Addendum to A12-B12-AC12 Reference Manual Rev E

List of known errors:

Figure 4.4: Connector Pinouts

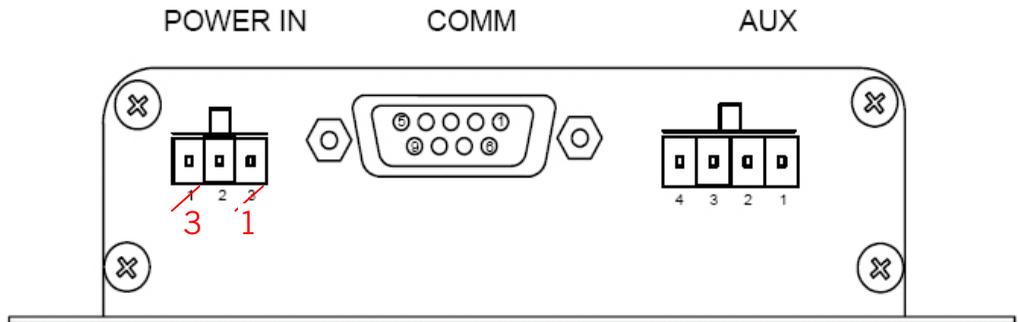
Figure 4-4 on page 36 is inaccurate. Pins 1 and 3 on the power connector should be inverted. Below is the corrected diagram.
